# Intel® Pentium® 4 Processor

## Specification Update

*November 2003*

Document Number: 249199-043

**Figure System Bus Reset and Configuration Timings**

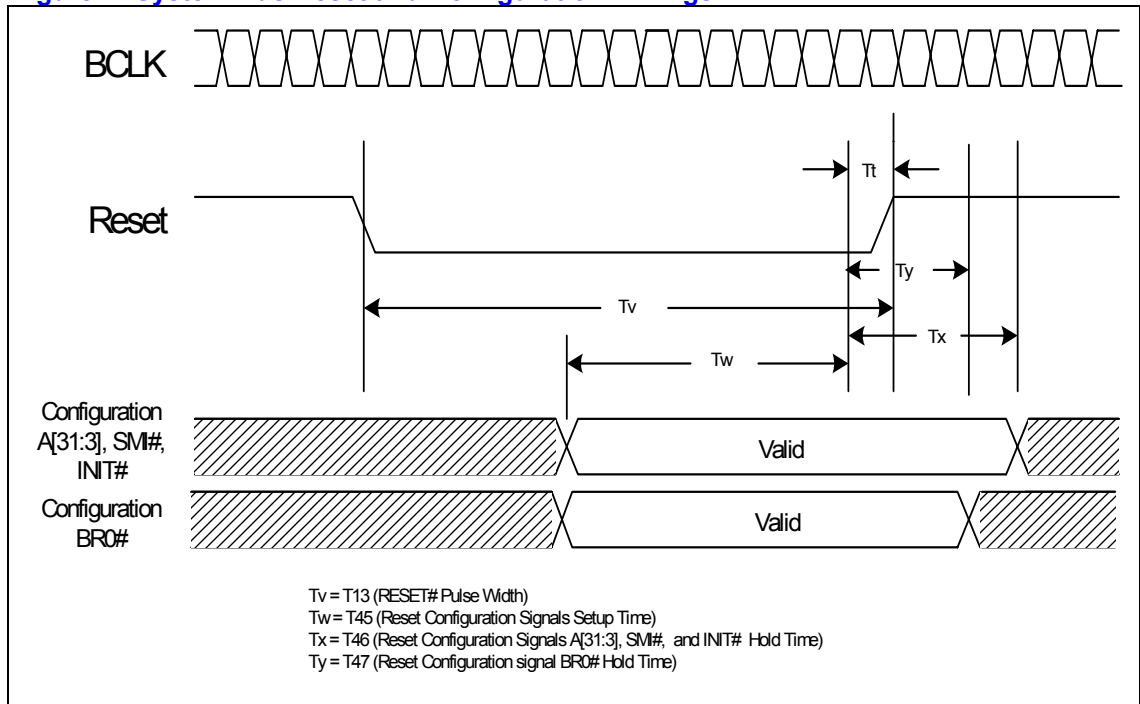
## N2. BR0# Maximum Hold Time Specification Change

The BR0# maximum hold time has changed to 2 BCLKs. This change will be shown in the “System Bus AC Specifications (Reset Conditions)” table and “System Bus Reset and Configuration Timings” figure of the Intel(R) Pentium(R) 4 Processor with 512KB L2 Cache on 0.13 Micron Process EMTS & Intel(R) Pentium(R) 4 Processor in the 478-pin Package Electrical, Mechanical, and Thermal Specifications (EMTS) & Intel(R) Pentium(R) 4 Processor in the 423-pin Package Electrical, Mechanical, and Thermal Specifications (EMTS). These changes will be incorporated in the next revision of the EMTS (Datasheet).

The following figure will be modified to reflect this change:

T# Parameter	Min	Max	Unit	Figure	Notes
T45: Reset Configuration Signals (A[31:3]#, BR0# INIT#, SMI#) Setup Time	4		BCLKs	12	1
T46: Reset Configuration Signals (A[31:3]#, INIT#, SMI#) Hold Time	2	20	BCLKs	12	2
T47: Reset Configuration Signal BR0# Hold Time	2	2	BCLKs	12	2
